Hanford Waste Management Area C WIR Evaluation 10-25-2018 DOE-NRC Teleconference Summary

The following topics regarding NRC's review of the Draft Waste Incidental to Reprocessing (WIR) Evaluation for Closure of Waste Management Area C (WMA C) at the Hanford Site were discussed during an October 25, 2018 teleconference. These topics on Saturated and Unsaturated Flow and Transport were scheduled to be discussed on the 10-11-18 teleconference but were omitted due to time constraints. The following non-sequential numbering is used to be consistent with the topic listing for the 10-11-18 teleconference. This teleconference was open to the public. The call in information for this teleconference was posted on the following DOE Hanford webpage:

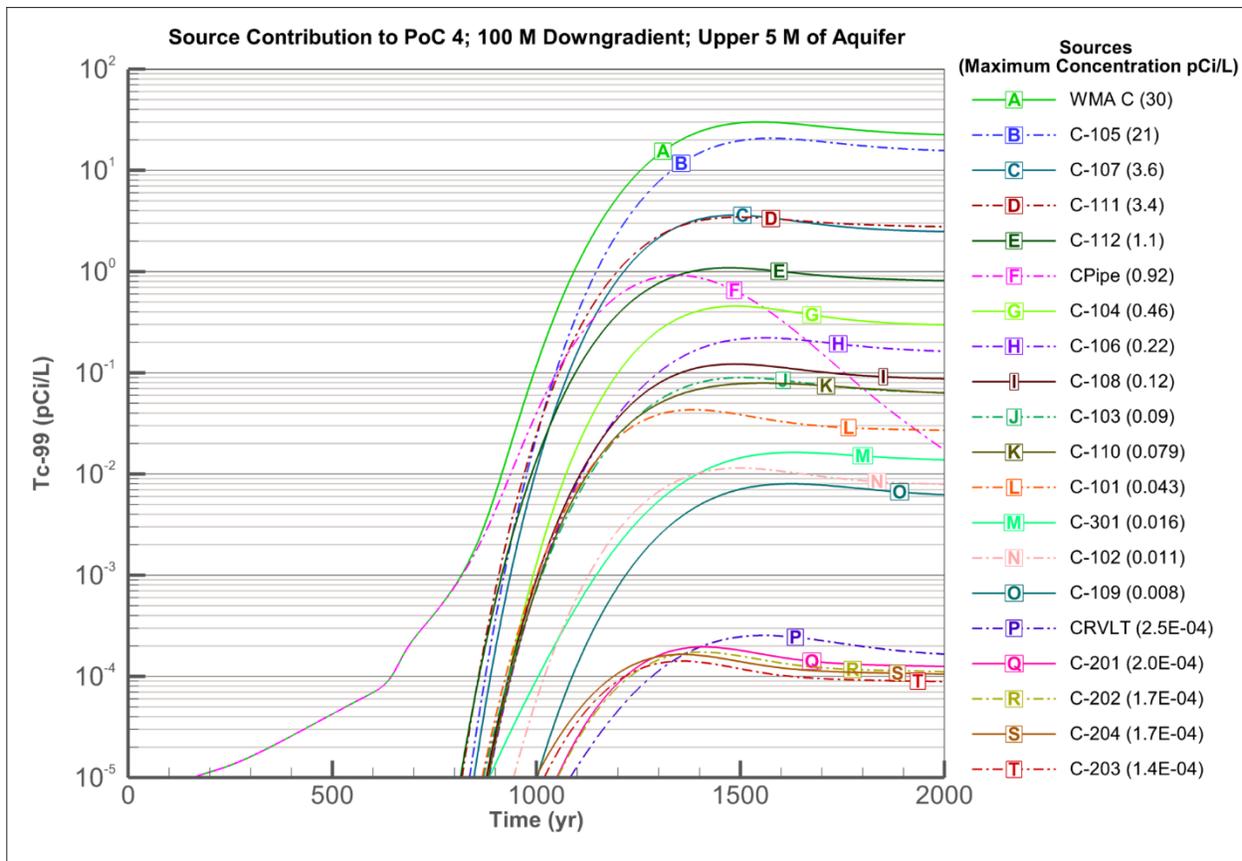
5. DOE provided additional detail regarding PA Figures 7-12, 7-13 and 7-14. DOE stated that the center point of the two cutaways is approximately Tank C-105 and confirmed that the largest contour interval presented in Figure 7-12 is 900,000 pCi/L. DOE additionally stated that there are 270 nodes with concentration greater than 900,000 pCi/L, and that the maximum concentration at any node is 6,055,749 pCi/L.
6. DOE provided the below figure illustrating the area used to represent the pipeline source within the STOMP model.

vzp05 Case Flow Field 1000 years after assumed closure

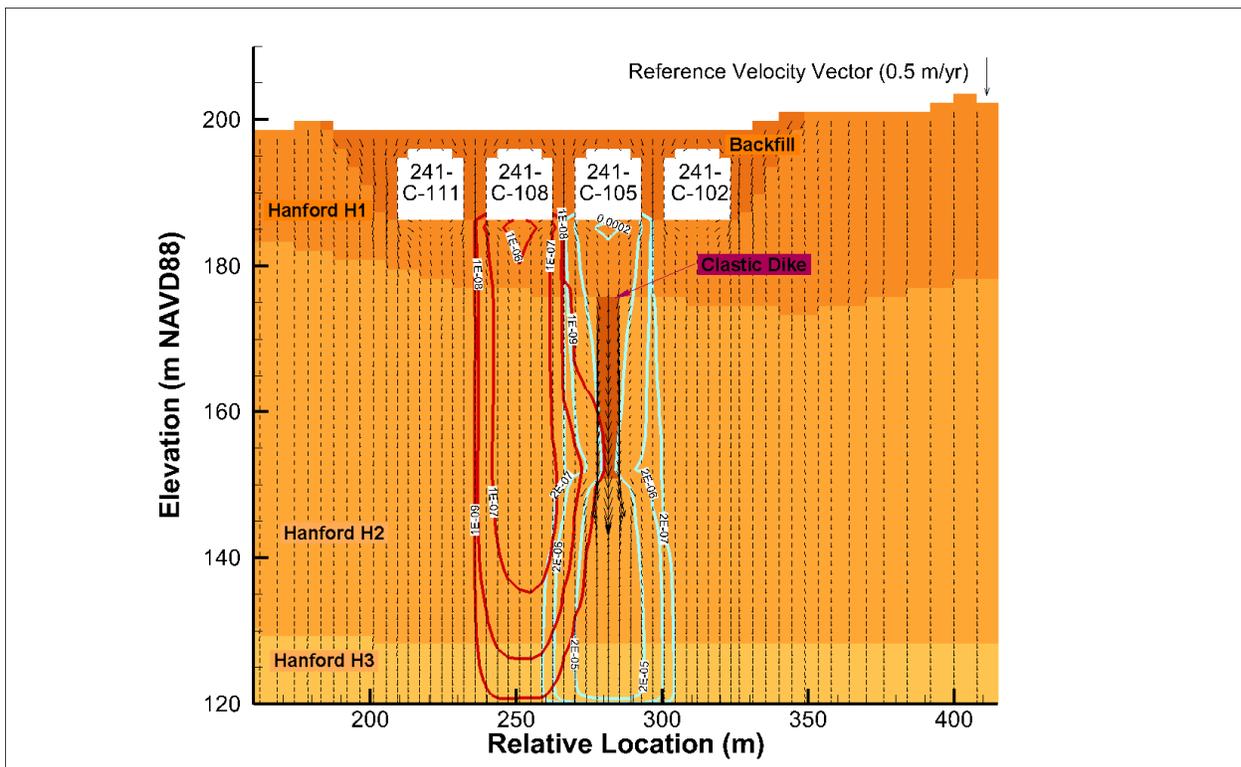
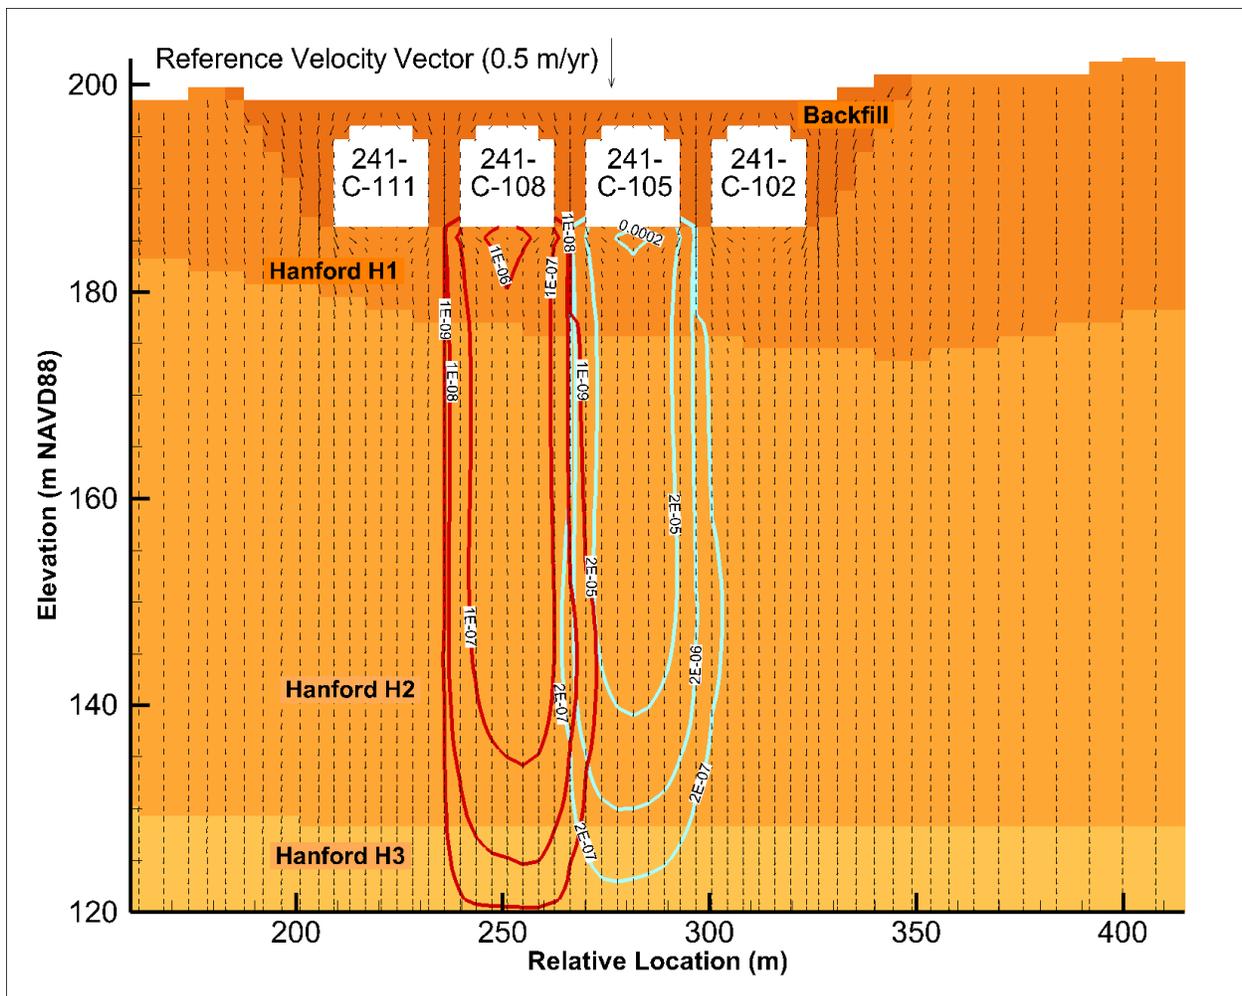
9. DOE provided supplemental information related to sensitivity case vzp05, including a figure that shows the location of the clastic dike modeled and its effect on unsaturated flow and transport. DOE also provided the below hydraulic parameters that were used to represent the clastic dike.
